SAN ANTONIO WATER SYSTEM
Interdepartment Correspondence Sheet

Subject: Zoning Case Z2023-10700184 (Kyle Seale Parkway MF-18)

Date: February 15, 2024

ZONING CASE: KYLE SEALE PARKWAY MF-18 46-ACRES (FIGURE 1)
ZONING FILE: Z2023-10700184

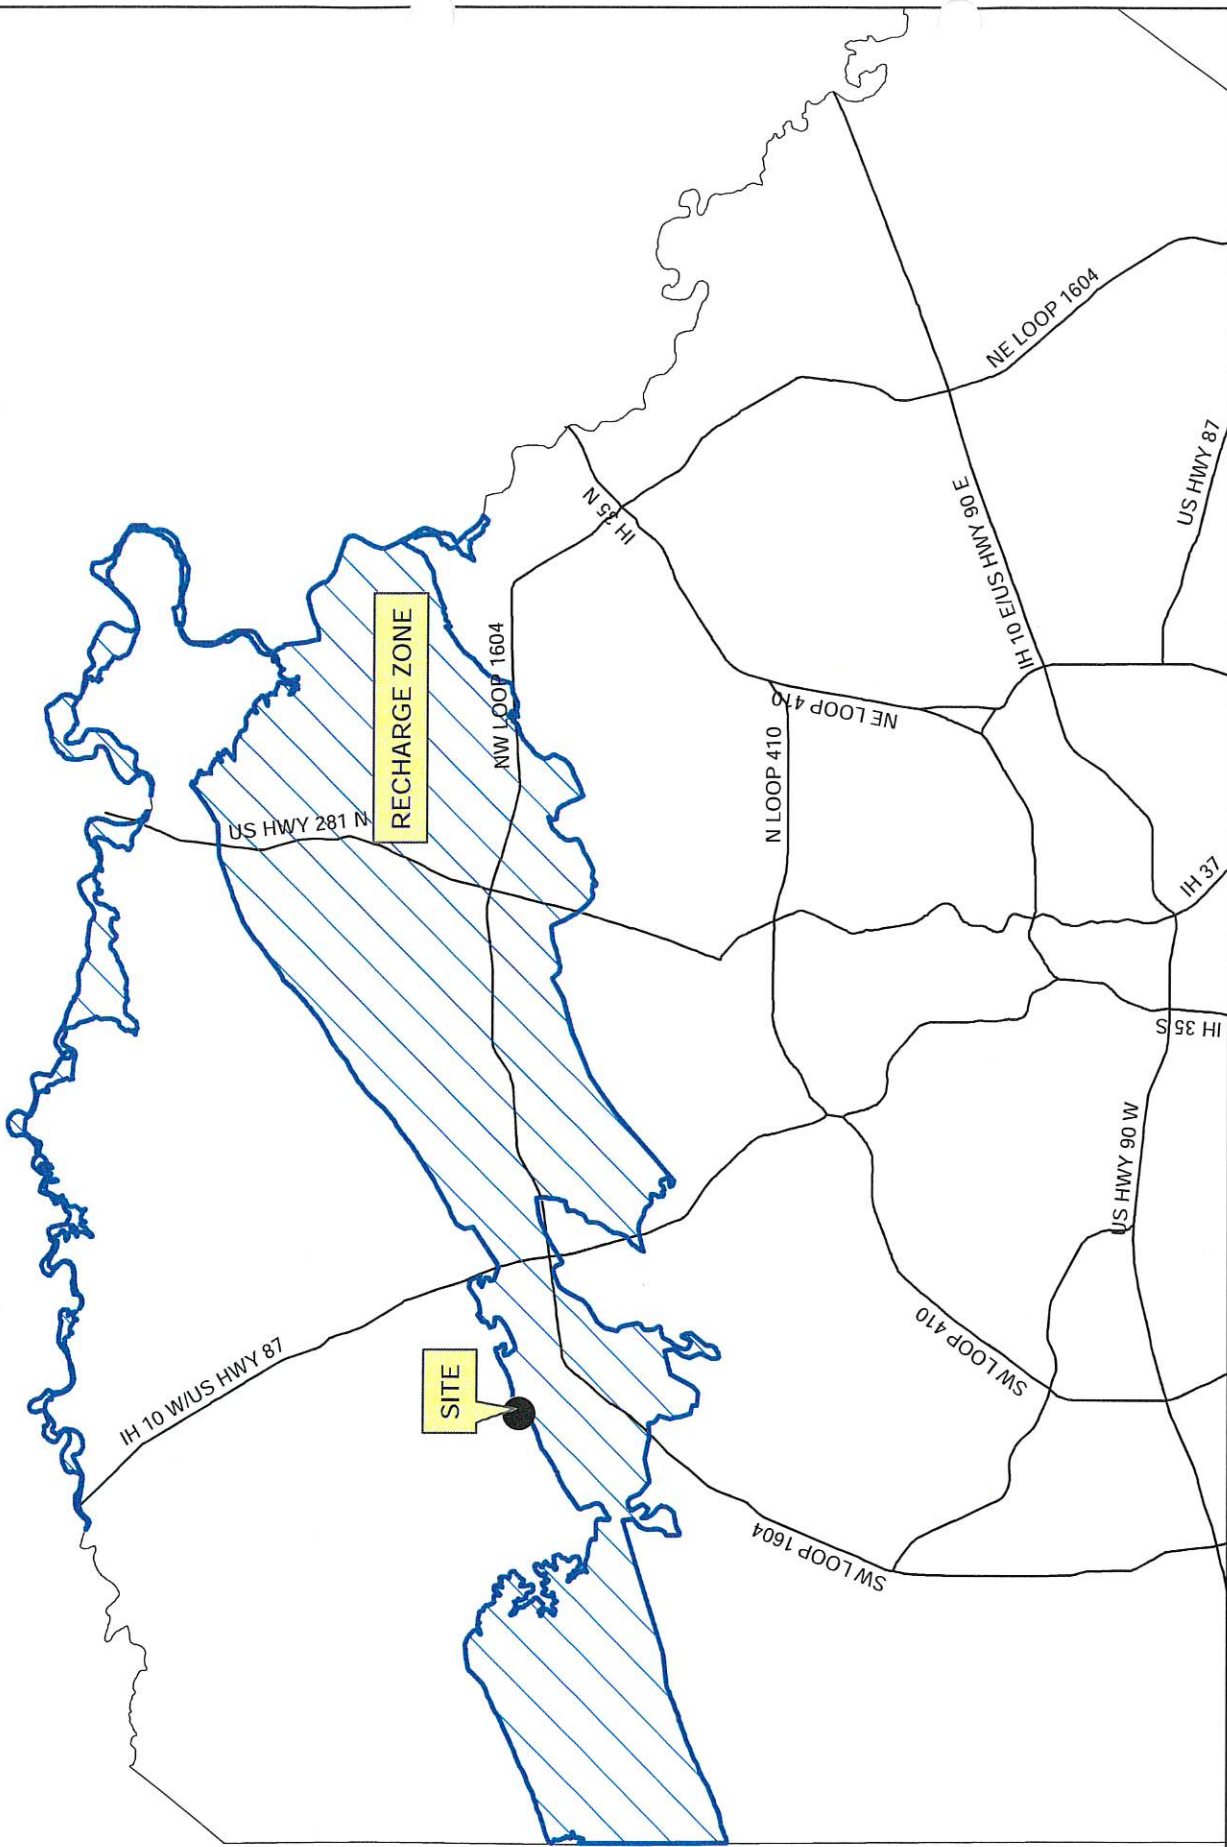
The subject property is in City Council District 8, approximately 1.5-miles north of Kyle Seale Parkway and North Loop 1604 West intersection. The southern and eastern portion of the property, 27.90-acres lies within the Edwards Aquifer Recharge Zone and the remaining 18.40-acres lies in the Contributing Zone (Figures 1 and 2).

1. The southwestern boundary of the property lies within the 100-year floodplain, where recharge may occur.

1. The impervious cover shall not exceed 50% on the approximately 27.90-acre portion of the site in the Edwards Aquifer Recharge Zone.
2. A floodplain buffer shall be provided along the southwestern boundary of the property as required in Ordinance No. 81491, Section 34-913.
